STATE OF HAWAII
DEPARTMENT OF TRANSPORTATION
HIGHWAYS DIVISION

ROADWAY DETAILS

KAHEKILI HIGHWAY WIDENING
Likelike Hwy. to Vicinity of Haiku Road
F.A. PROJECT NO. NH-083-1(26)

ROADWAY DETAILS	
KAHEKILI HIGHWAY WIDENING Likelike Hwy. to Vicinity of Haiku Road F.A. PROJECT NO. NH-083-1(26) SCALE: AS NOTED DATE: APRIL 1994 SHEET No. T5 OF T13 SHEETS AS-BUILT ADD. 5

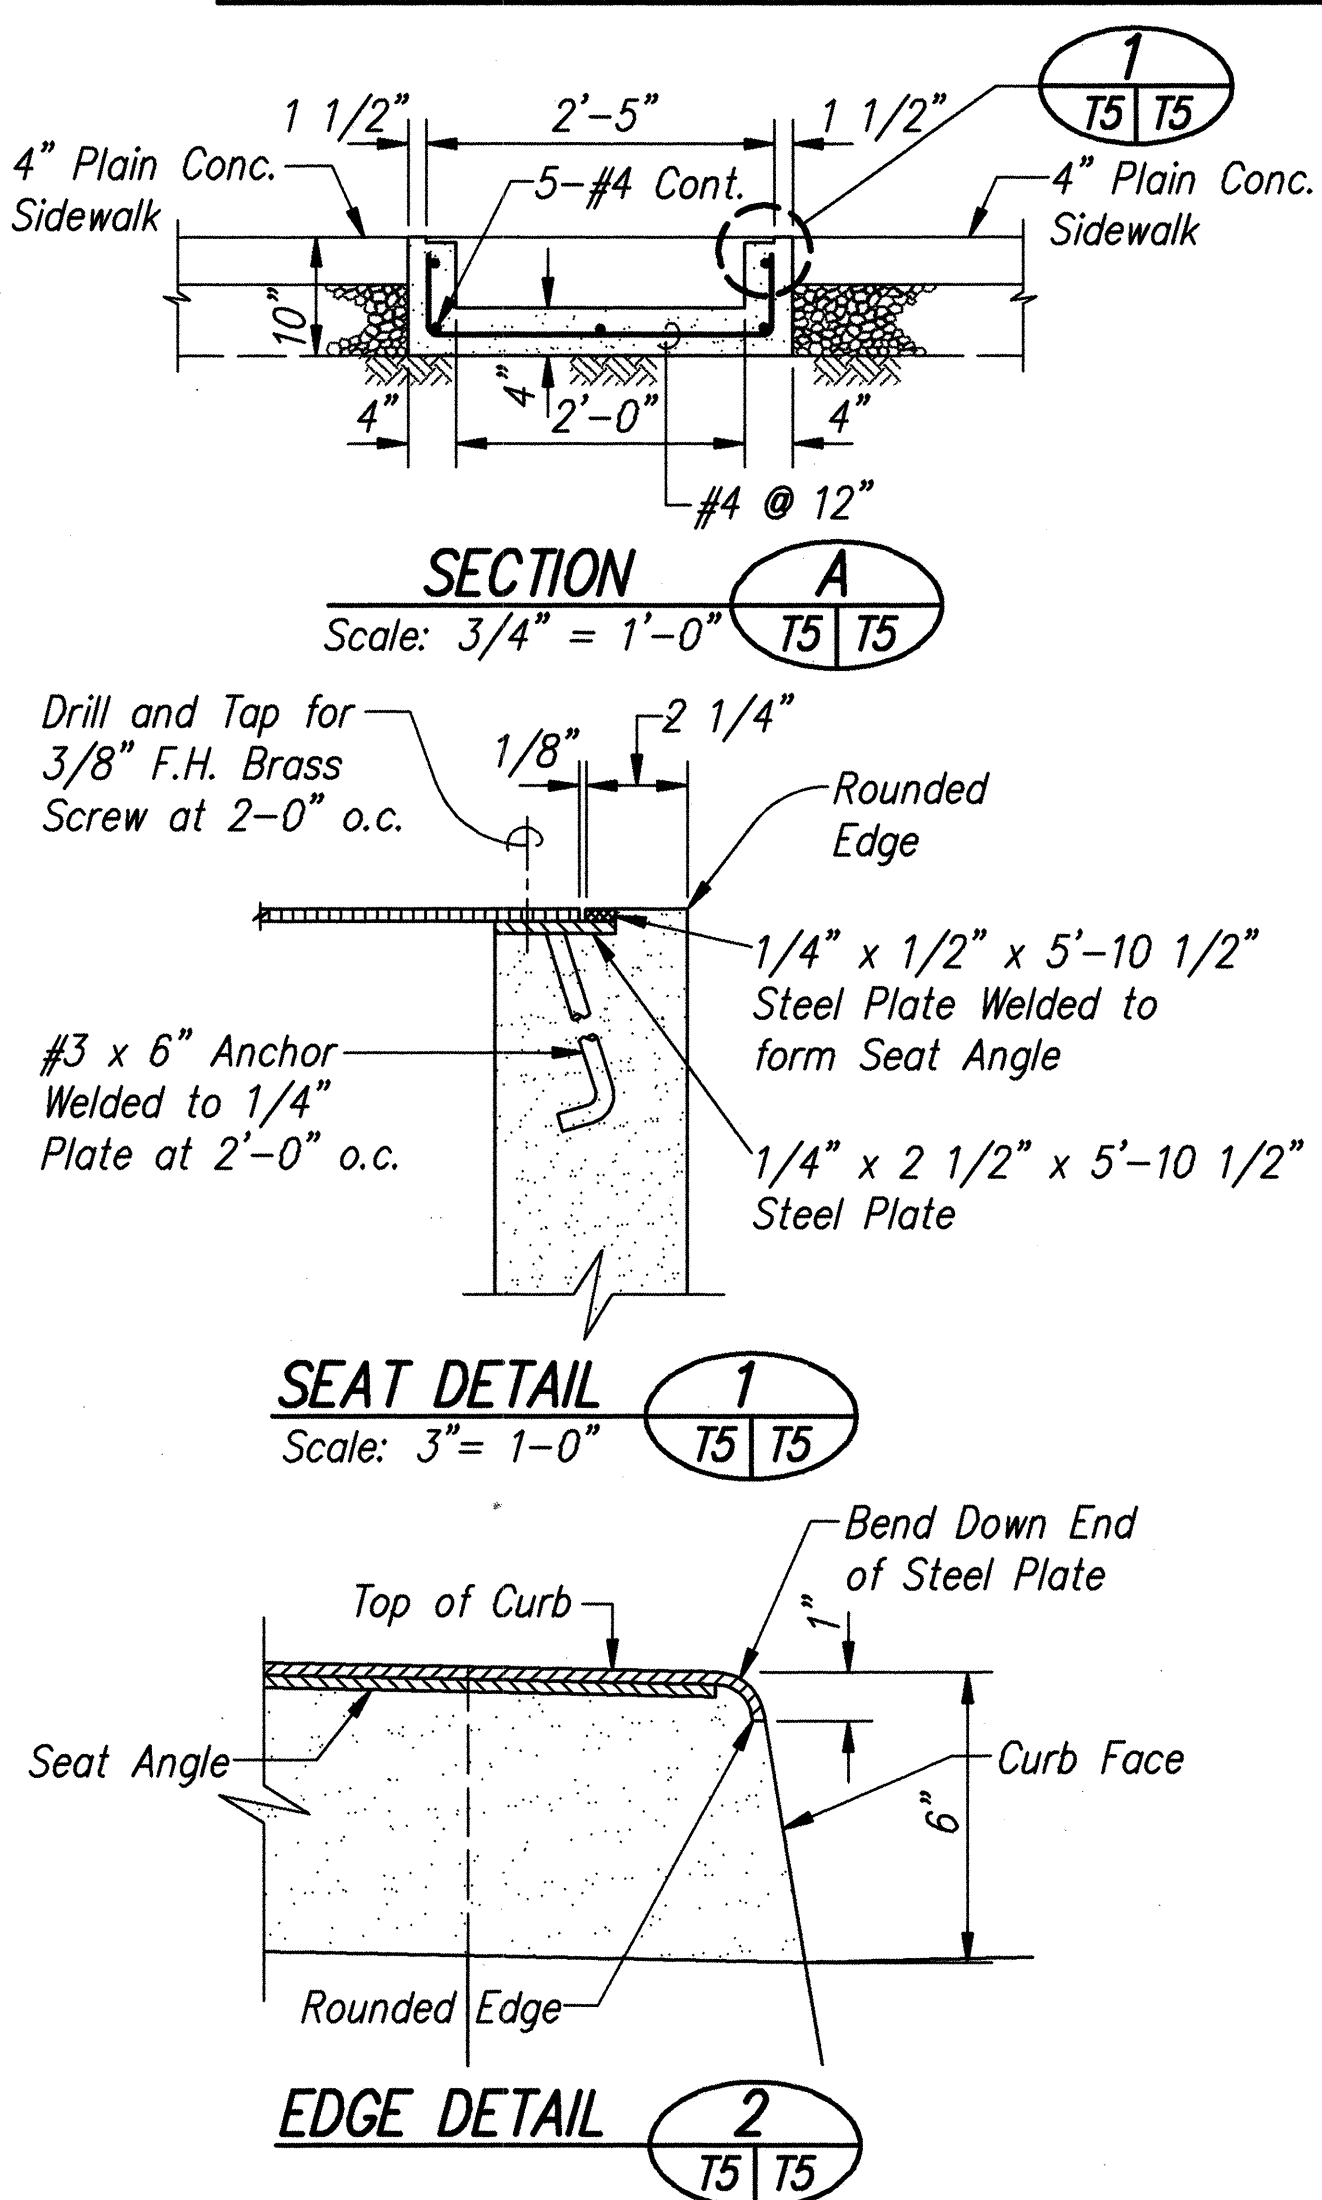
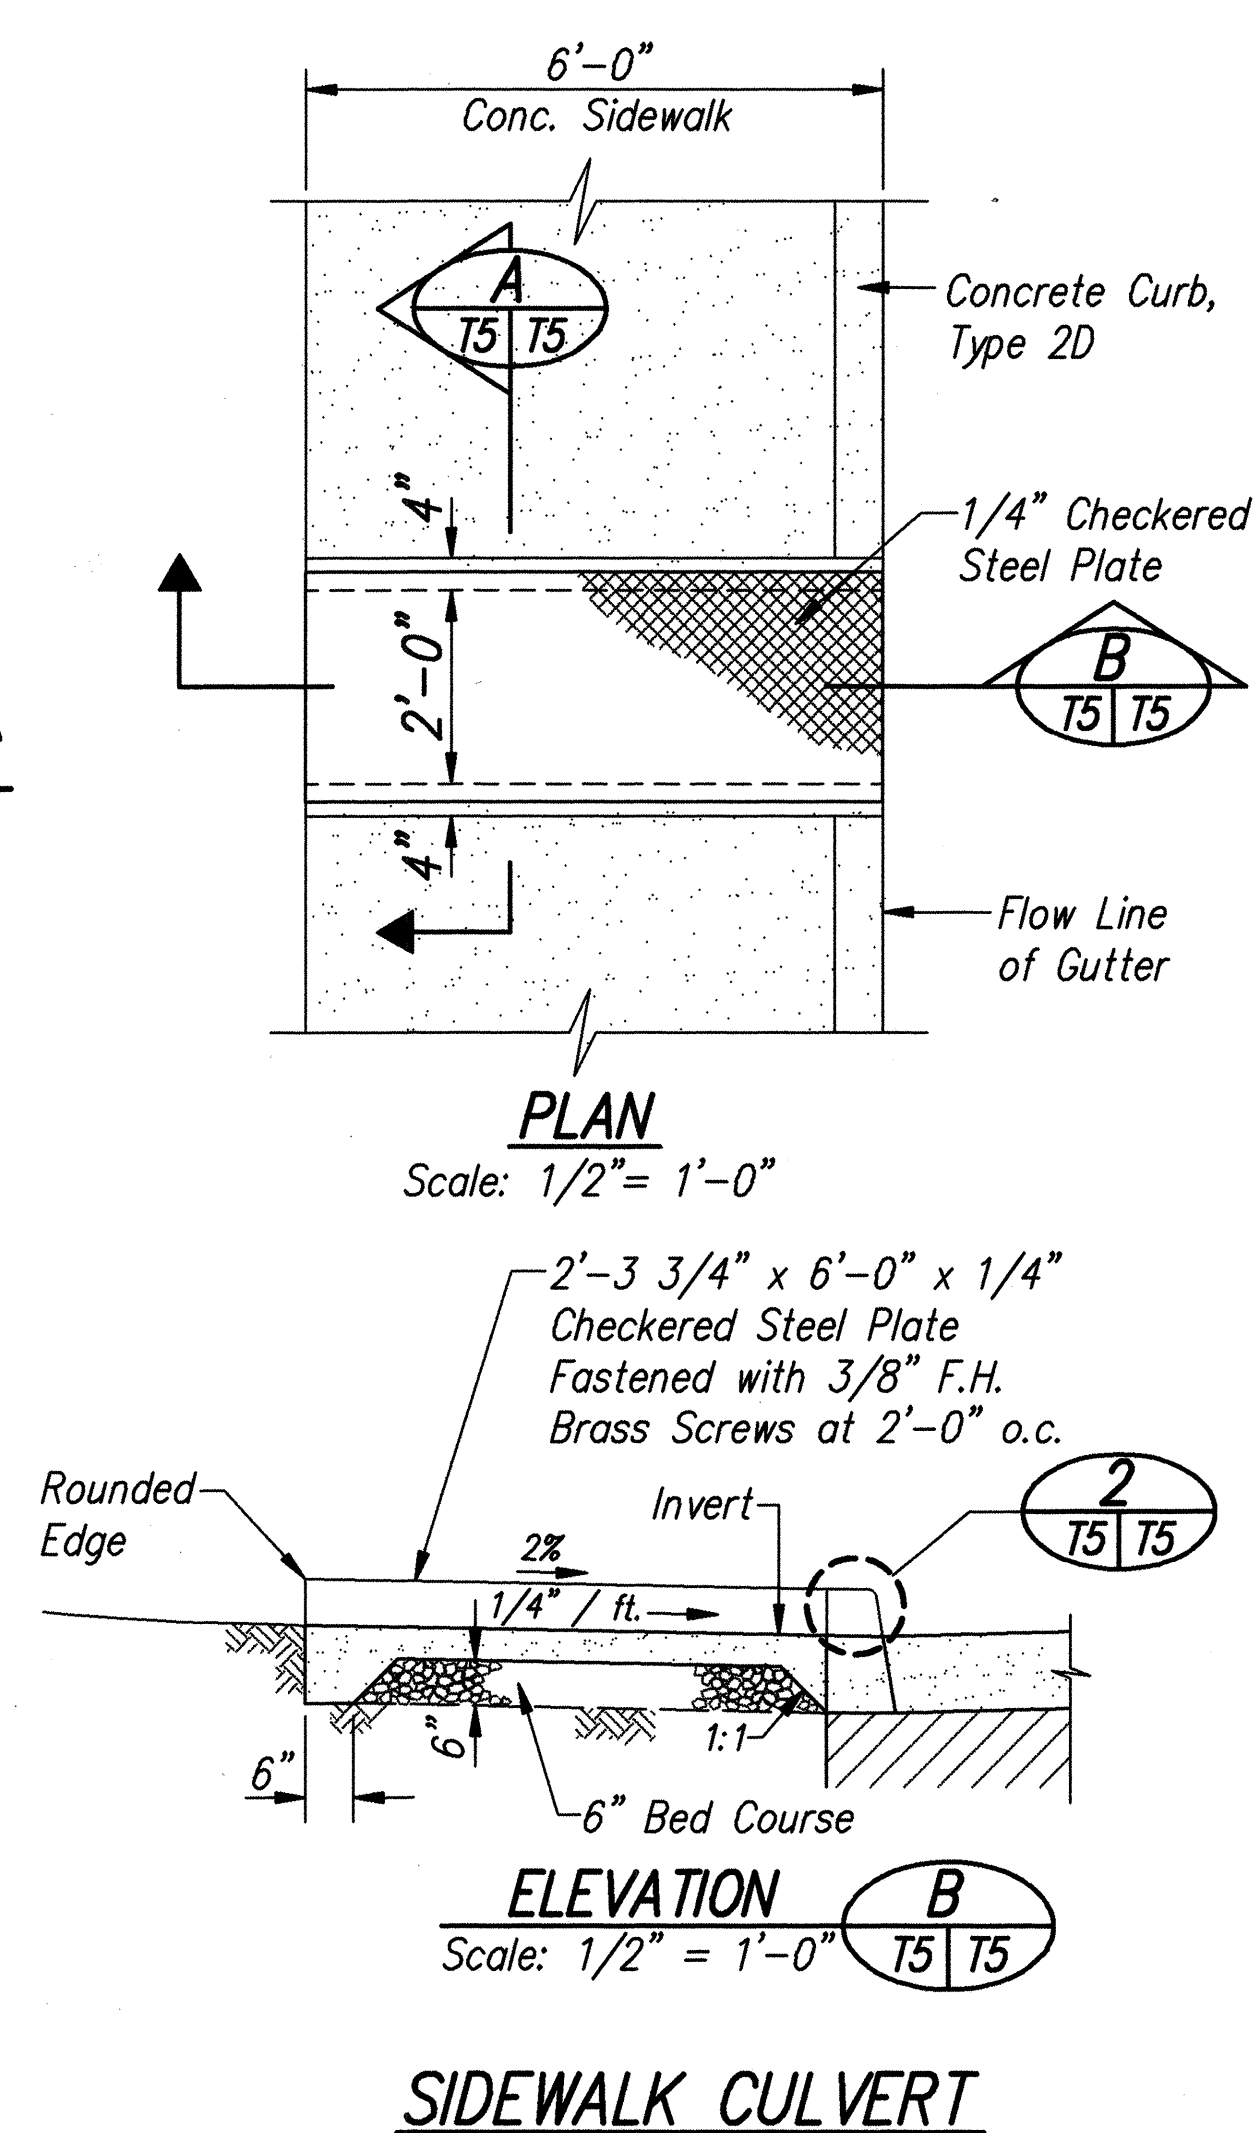
DATE	REVISION
6/07/94	REVISED REINFORCED CONCRETE BUSPAD/BIKE LANE DETAILS AND NOTES.

PARK ACCESS
 STA. 42+30.33 TO STA. 42+35.33
 Scale: 3/4" = 1'-0"

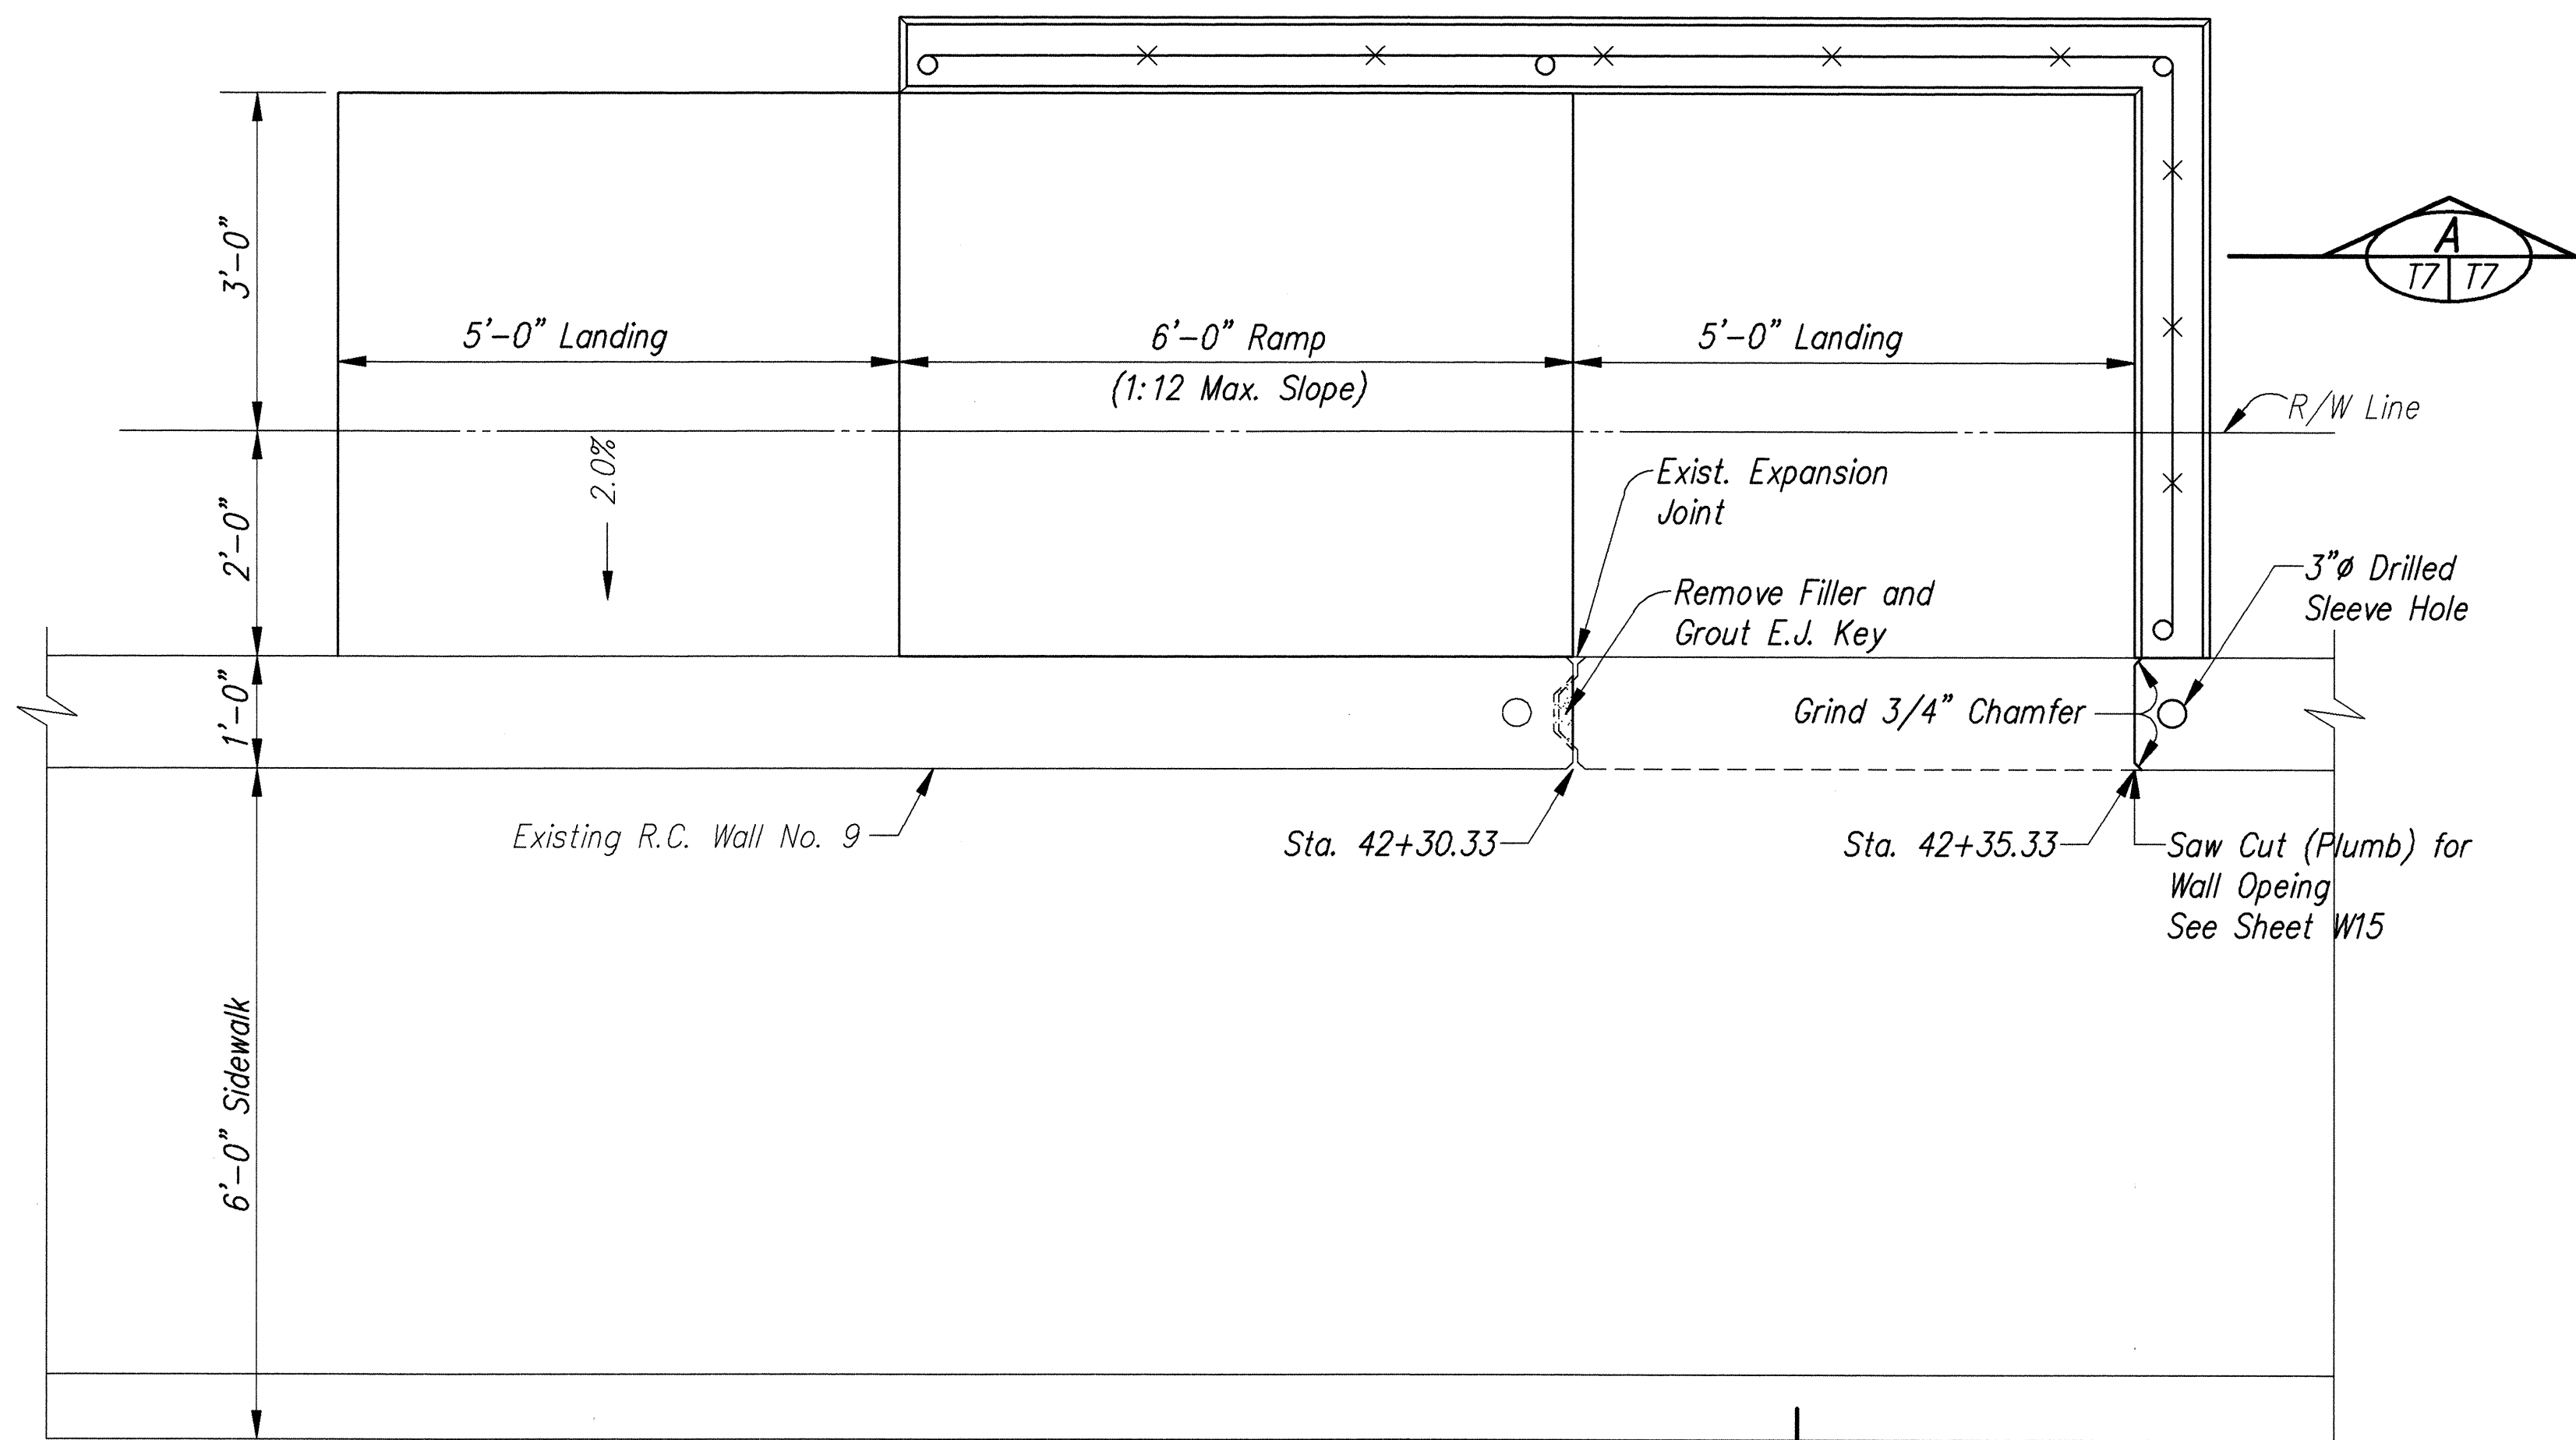
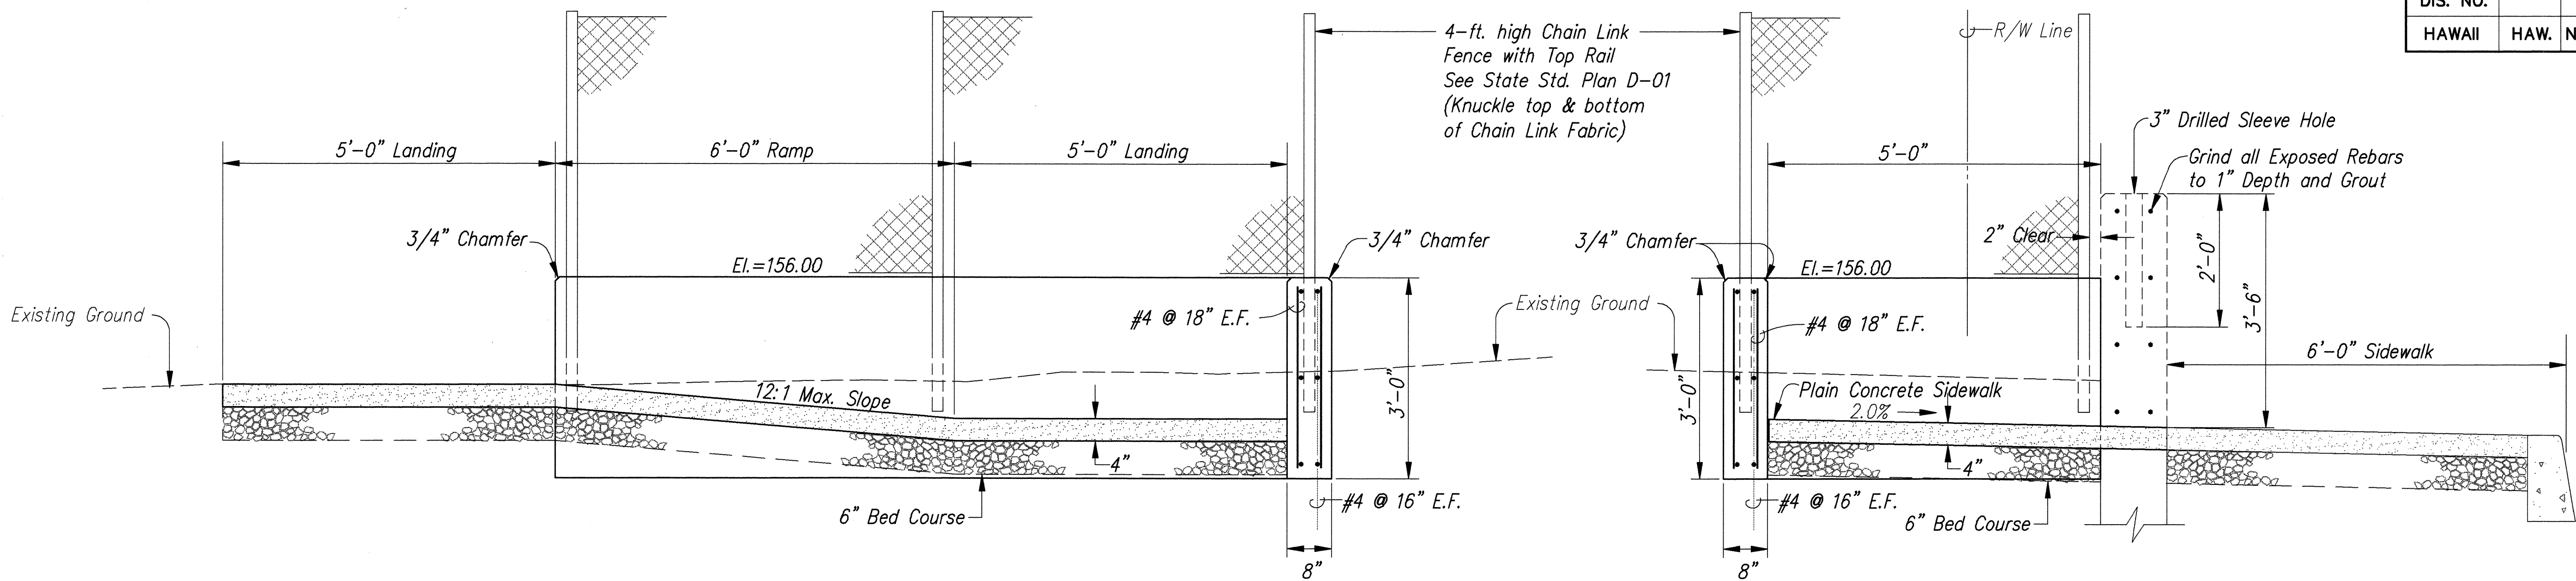
1/17/97	ADDED DETAIL FOR PARK ACCESS STA. 42+30.33 TO STA. 42+35.33
DATE	REVISION
